Sterling Ranch Sketch Plan Amendment Master Traffic Impact Study

October 26, 2022

SKP-22-004

LSC Responses to TIS Redline Comments

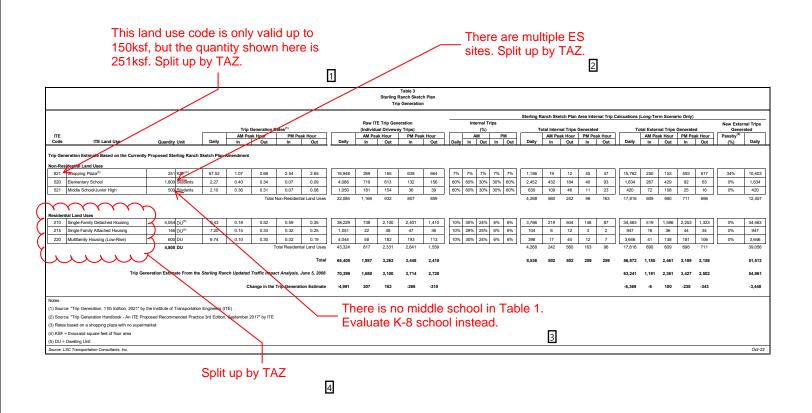
Number: 1 Author: Paul Brown Subject: Callout Date: 12/14/2022 17:58:41 This land use code is only valid up to 150ksf, but the quantity shown here is 251ksf. Split up by TAZ. Author: kdferrin Subject: Sticky Note Date: 12/22/2022 17:14:54

LSC Response: A detailed trip generation table by traffic analysis zone has been included in the appendix of the updated Master TIS. Number: 2 Author: Paul Brown Subject: Callout Date: 12/14/2022 17:59:00 There are multiple ES sites. Split up by TAZ. Author: kdferrin Subject: Sticky Note Date: 12/22/2022 17:12:33

ESC Response: A detailed trip generation table by traffic analysis zone has been included in the appendix of the updated Master TIS Number: 3 Author: Paul Brown Date: 12/14/2022 18:01:07 Subject: Callout There is no middle school in Table 1. Evaluate K-8 school instead. Author: kdferrin Subject: Sticky Note Date: 12/22/2022 17:13:48

LSC Response: ITE does not provide trip generation rates for public K-8 schools. LSC believes it is more appropriate to estimate the trip generation for a public K-8 school by adding estimates using the rates for elementary school and a middle school than to use the rates for a K-8 Private School Subject: Sticky Note Number: 4 Author: Paul Brown Subject: Cloud+ Date: 12/14/2022 18:00:54 Split up by TAZ Author: kdferrin Subject: Sticky Note Date: 12/22/2022 17:14:57

LSC Response: A detailed trip generation table by traffic analysis zone has been included in the appendix of the updated Master TIS.

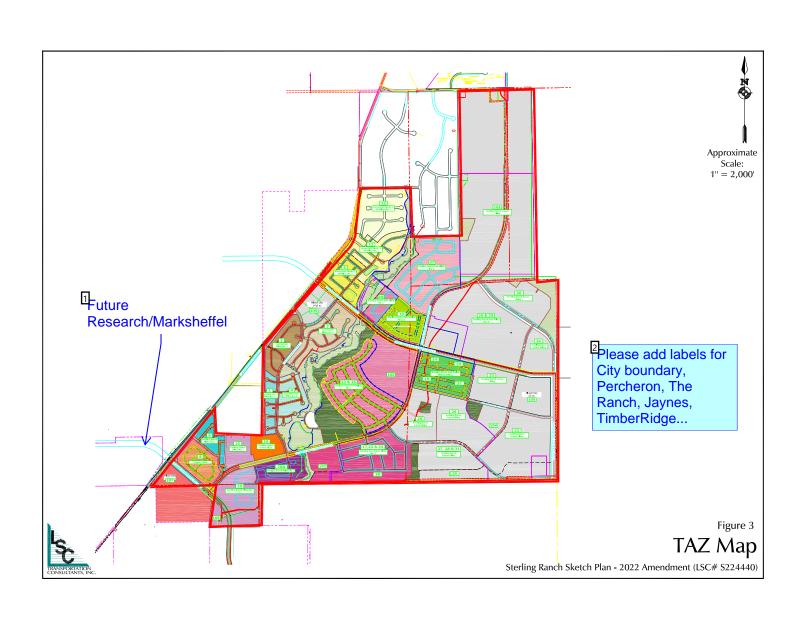
Number: 1 Author: Paul Brown Subject: Callout Date: 12/14/2022 18:02:10

Define trigger.

Number: 2 Author: Paul Brown Subject: Text Box Date: 12/14/2022 18:02:55

Removal of bike lane is not appropriate. Consider other improvement option(s).

LSC Response: The triggers are listed in the preceding line item under design ADT (directional northbound and southbound).

LSC Response: The rationalle behind this concept was that the section of Vollmer connecting to this section will have an Urban Minor Arterial cross section, which does not include a bike lane or outside paved shoulder. We have retained this description to be consistent with recent prior TIS reports. This description includes the note indicating that City Traffic Engineering concurrence/approval is required with this note: "Pending City Traffic Engineering Approval."

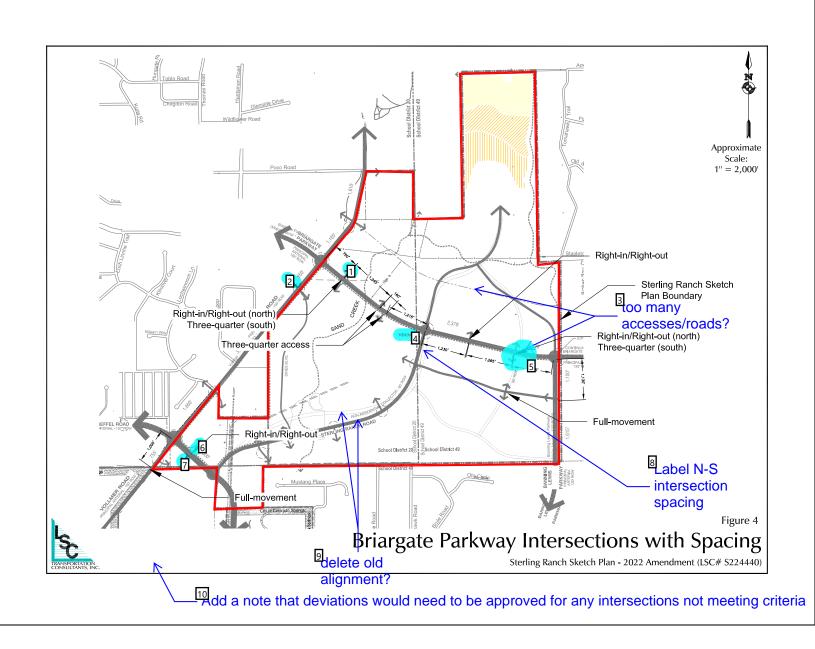
Number: 1 Author: dsdrice Subject: Callout Date: 12/9/2022 14:13:53

Future Research/Marksheffel

LSC Response: Modified as requested.

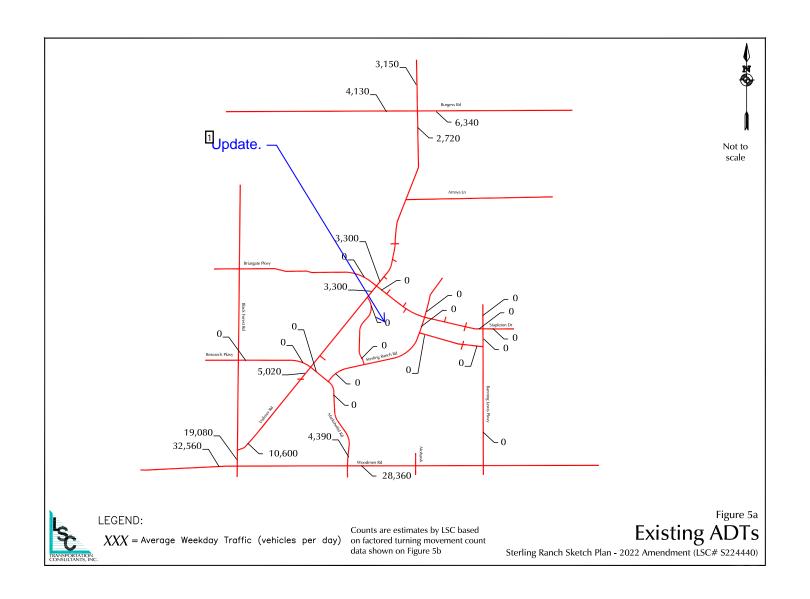
Number: 2 Author: dsdrice Subject: Text Box Date: 12/9/2022 14:12:45

Please add labels for City boundary, Percheron, The Ranch, Jaynes, TimberRidge...

LSC Response: Modified as requested.

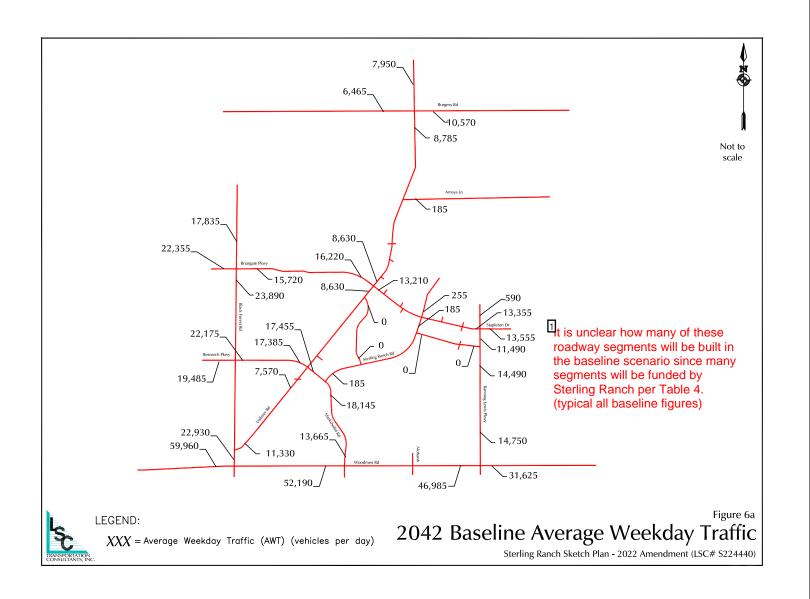
Number: 1 Author: dsdrice Subject: Callout Date: 12/9/2022 14:18:31

Update.

ISC Response: The figure has been updated as requested.

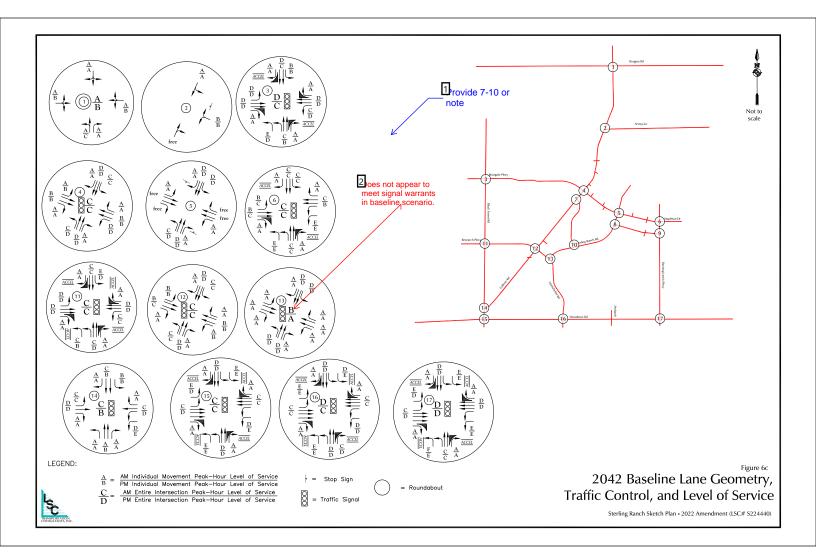
Number: 1 Author: Paul Brown Subject: Text Box Date: 12/14/2022 18:04:10

It is unclear how many of these roadway segments will be built in the baseline scenario since many segments will be funded by Sterling Ranch per Table 4. (typical all baseline figures)

LSC Response: The Baseline Scenairo is a theoretical scenrio that assumes no traffic generated by land uses within Sterling Ranch (including existing land uses) but assumes the street network is built out. The purpose of this scenario is to evaluate the background assumptions used to calculate the total traffic volumes and potentially to determine the percent impacts due to Sterling Ranch traffic.

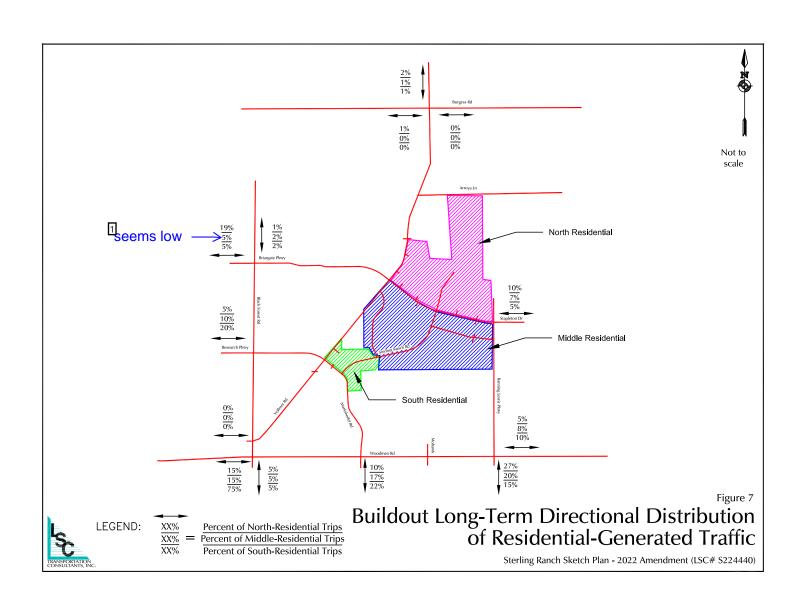
Number: 1 Author: dsdrice Subject: Callout Date: 12/9/2022 14:35:46

Provide 7-10 or note

Number: 2 Author: Paul Brown Subject: Callout Date: 12/14/2022 18:04:52

Does not appear to meet signal warrants in baseline scenario.

LSC Response: The figures have been revised to include intersections 7-10

SCR Response: This level of service analysis for this intersection has been revised to two-way, stop-sign control for the baseline scenario.

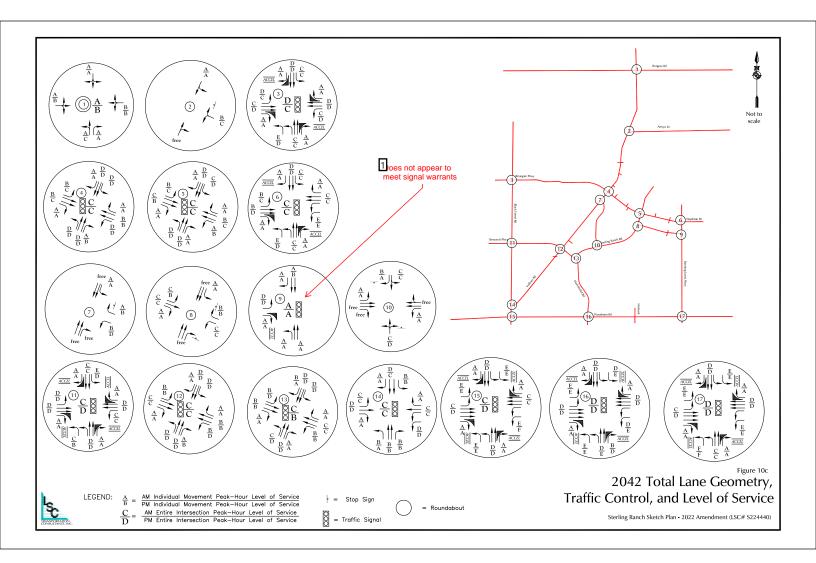
Number: 1 Author: dsdrice Subject: Callout Date: 12/9/2022 14:40:55

seems low

ISC Response: A topographical error has been corrected on this figure in the updated Master TIS. The distribution percentage of trips for the middle residential area are to and from the west on Briargate west of Black Forest Road was assumed to be 15%.

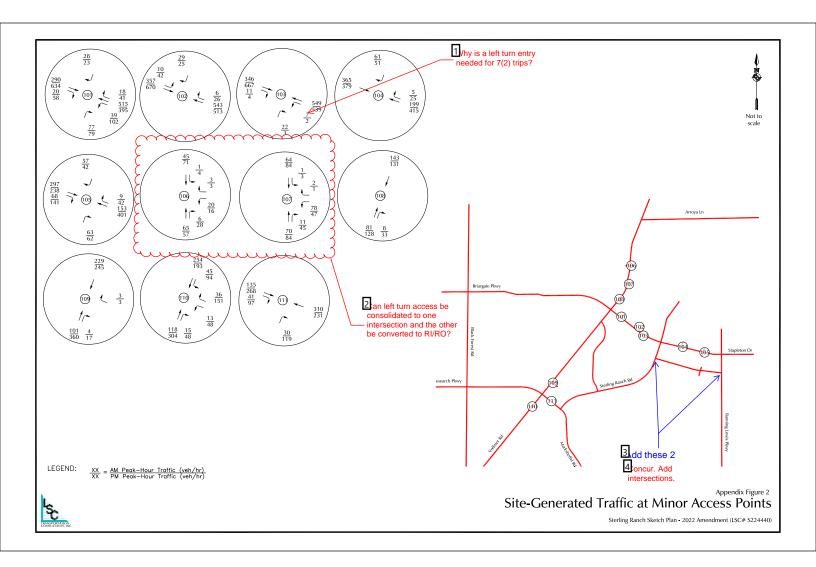
Number: 1 Author: Paul Brown Subject: Callout Date: 12/14/2022 18:05:52

Does not appear to meet signal warrants

Number: 1 Author: Paul Brown

Why is a left turn entry needed for 7(2) trips?

Number: 2 Author: Paul Brown Subject: Cloud+ Date: 12/14/2022 18:08:42

Can left turn access be consolidated to one intersection and the other be converted to RI/RO?

Number: 3 Author: dsdrice Subject: Callout Date: 12/15/2022 09:08:16

Add these 2

Number: 4 Author: Paul Brown Subject: Text Box Date: 12/14/2022 18:09:11

Concur. Add intersections.

LSC Response: Detailed traffic signal warrants will be provided with a future preliminary plan and/or final plat submittal. The purpose of this Master TIS is to only identify intersections that may need to be signal controlled in the future to provide information as this area is planned.

ISC Response: Intersection #103 is needed to serve the future K-8 school site. There are currently no plans available that show the school layout and access plan. This Master TIS assumed the access to Briargate Parkway would serve a bus loop only, however, this intersection is requested as a 3/4 movement access to provide flexibility as actual designs are prepared for the

ISC Response: Intersection #106 (Poco/Vollmer) is an existing full-movement intersection. Intersection #107 (Sam Bass/Vollmer) is planned as a full-movement intersection as part of Homestead North Fil 2 (PCD No. SF 2218) and Homestead North Fil 3 (PCD No. SF 2229). Traffic reports for both of these projects have been through multiple reviews and only minor comments are left to be resolved. It is anticipated that they will be approved in the short-term future.

Author: kdferrin Subject: Sticky Note Date: 12/22/2022 1 LSC Response: These intersections are included as #8 and #9 on Figure 9b. Date: 12/22/2022 19:44:29

Author: jchodsdon Subject: Sticky Note Date: 12/22/2022 19:44:49 LSC Response: These intersections are included as #8 and #9 on Figure 9b.

2008 TIS TAZ Map

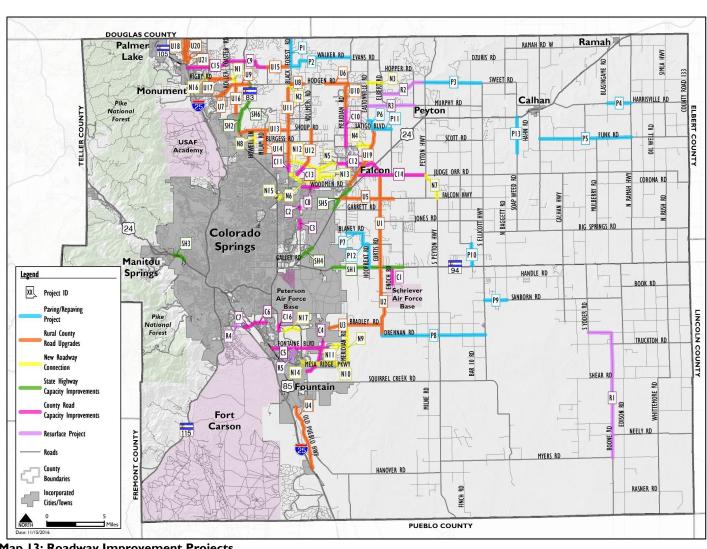
Number: 1 Author: Paul Brown Subject: Text Box Date: 12/14/2022 18:10:22

The next page is included in the previous section., Can this cover page and the duplicate figure be removed?

LSC Response: This section has been removed in the updated TIS

Timings 14: Black Forest Rd & Vollmer Rd

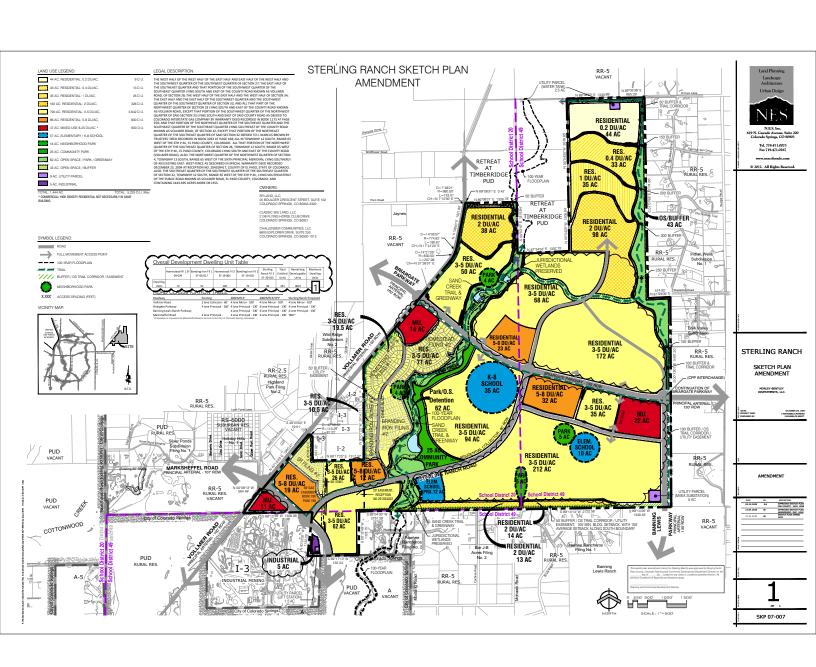
Number: 1 Author: Paul Brown Subject: Cloud+ Date: 12/14/2022 18:13:36

Provide justification for lost time adjustments or remove (typical all signalized analyses)

ISC Response: The analysis has been updated for all scenarios to assume 0 seconds of lost time for all signalized intersections.
